Builder	DRB Group
Region	North Carolina
Division	Raleigh
Community	Sidney Creek SF 40's (NC)(RAL)
Lot	00.0495
Street Address	532 Hipwood Dr.
Field Manager	Daniel Morris
	Eric Morphy
Reviewer	Jon Bennett
Date	6/17/2026
Type	New Review
Product Type

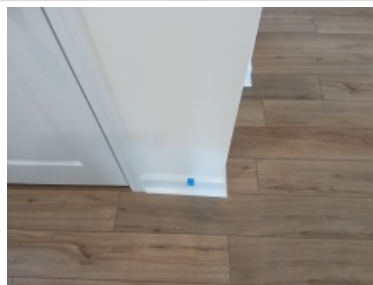
Kitchen/Dinette
1050 - Bowed Wall
Front left side of island wall is bowed

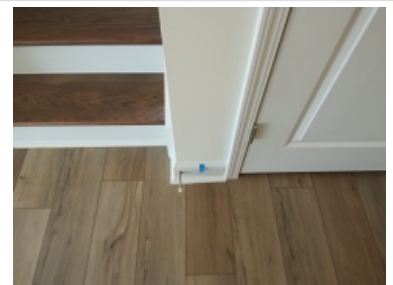
Kitchen/Dinette
1410 - Major Drywal Issue
Drywall on right outer side of island is bowed/wavy
